**Landing Real Estate Office, 79 Tandberg Trail**  
**Response to Peer Review Comments**

Landing Real Estate Office

## STORMWATER MANAGEMENT REPORT

AUGUST 2016  
REVISED 8-30-2016

**SHEET DESCRIPTION**  
LANDING REAL ESTATE OFFICE  
79 TANDBERG TRAIL, WINDHAM, MAINE  
POST-DEVELOPMENT WATERSHED PLAN

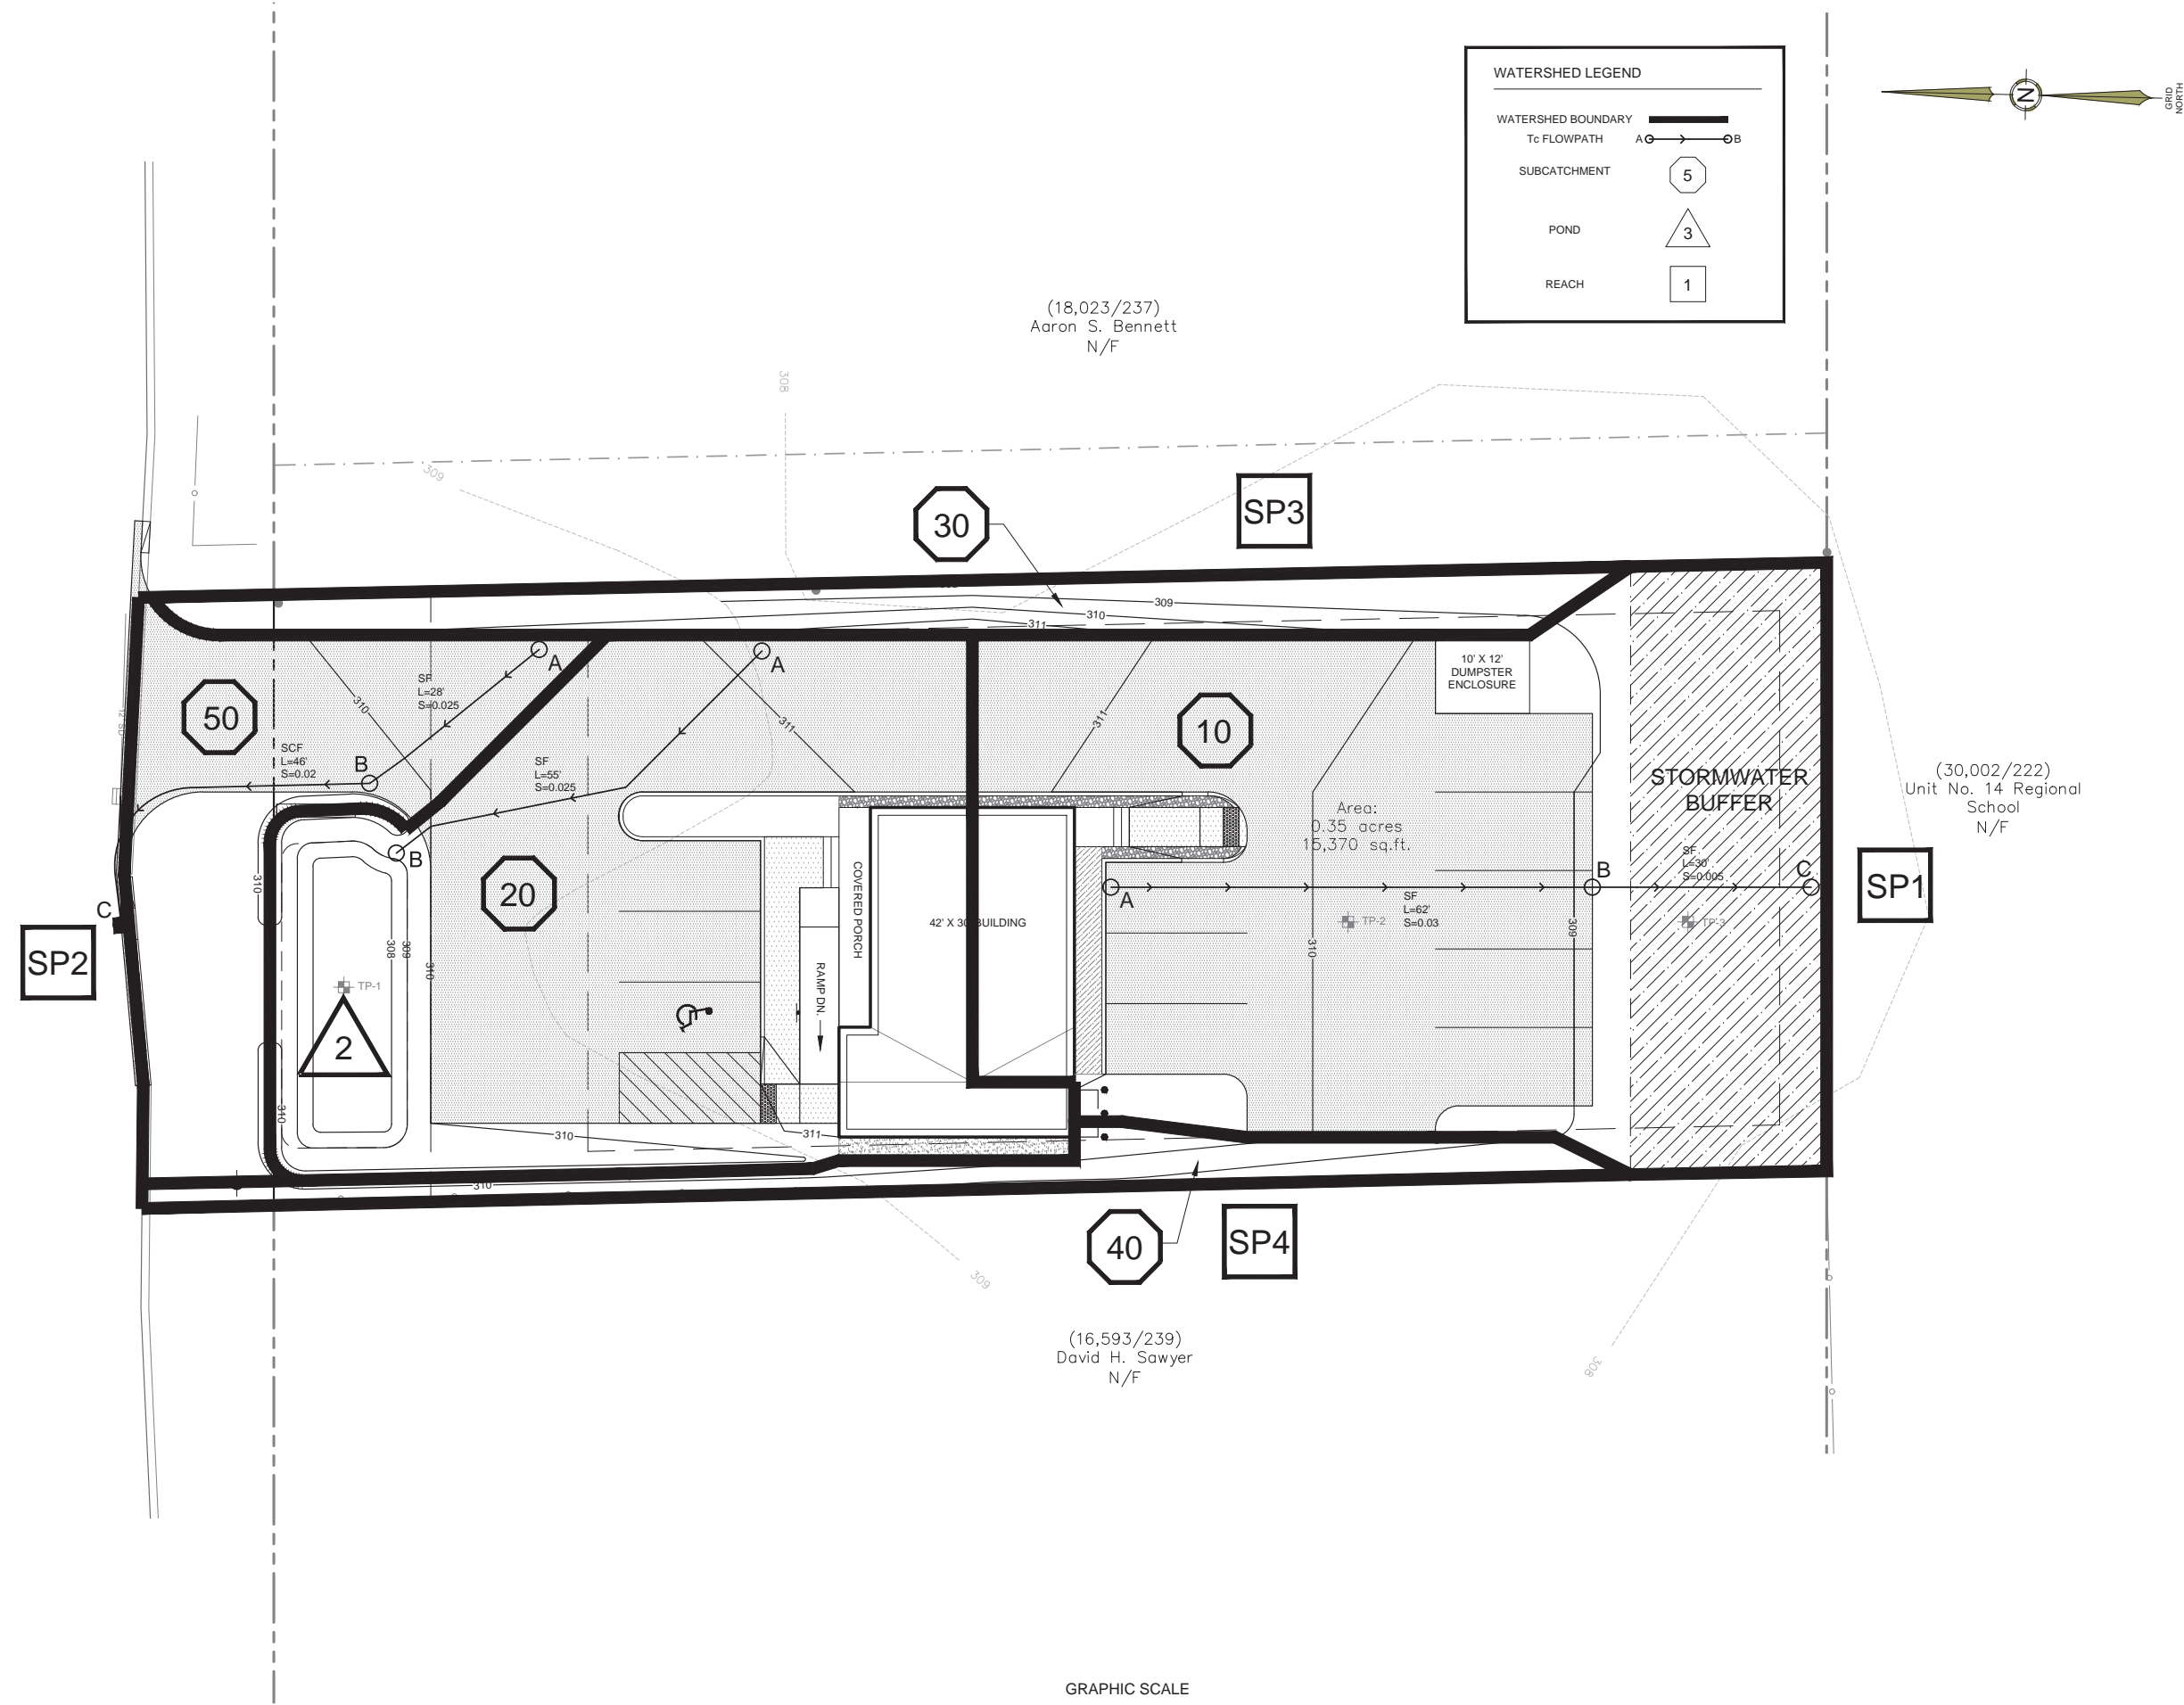
5. *Based on discussions with the Public Works Director, our understanding is that private drainage from an enclosed drainage system cannot be connected to the public storm drain system, therefore, CB2 shall not be connected to the relocated CB1. This will require that the stormwater management design for this project be revisited.*

7. *Proposed CB2 is located in the road right-of-way. We recommend this be relocated outside the right-of-way. The current design of the stormwater infiltration basin allows stormwater to pond into the road right-of-way. The basin should be redesigned to keep the ponded water completely on the property.*

Proposed catch basin CB2 has been eliminated. See the response to comment #7 for more information on the redesigned infiltration basin.

Proposed catch basin CB2 has been eliminated, and the infiltration basin has been revised to keep ponding water completely on the project site. The depth of the infiltration basin has been increased by one foot in order to increase its capacity. The basin will now retain and infiltrate all runoff from the 25-year design storm event. A grass spillway has been designed on the north side of the basin to convey runoff toward Tandberg Trail and the relocated catch basin CB1 in the event of a storm greater than the 25-year design storm or if the basin were to become clogged.
